UNITED STATES PATENT AND TRADEMARK OFFICE

APPLICATION NO.	FILING DATE	FIRST NAMED INVENTOR	ATTORNEY DOCKET NO.	CONFIRMATION NO.
10/728,908	12/08/2003	Toshio Maruyama	A-9993	9304

Office Action Summary	Application No. 10/728,908	Applicant(s) MARUYAMA ET AL.	
	Examiner Katherine W. Mitchell	Art Unit 3677

DETAILED ACTION

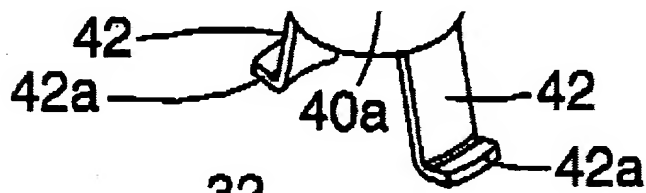
(46a) extending into the interior of the shank, wherein the shank {is capable of} has a length less than that of a stem of a stud fixed to a mounting member with which the fastener is to be engaged, so that the stud stem protrudes from a first surface of the sheet-shaped member after the shank is inserted into the mounting hole, with the holding piece leading, until the holding piece is juxtaposed with the first surface and the flange is juxtaposed with an opposite second surface of the sheet-shaped member, and the stud is passed through the shank and the pawl is engaged with the stud, and wherein protrusion of the stud stem allows an auxiliary member to be mounted thereto (inherently capable of this function – no structure positively recited), wherein there are a plurality of the stud-engagement pawls, (two are shown in the figure) each extending radially inward from a position near the first end of the shank.
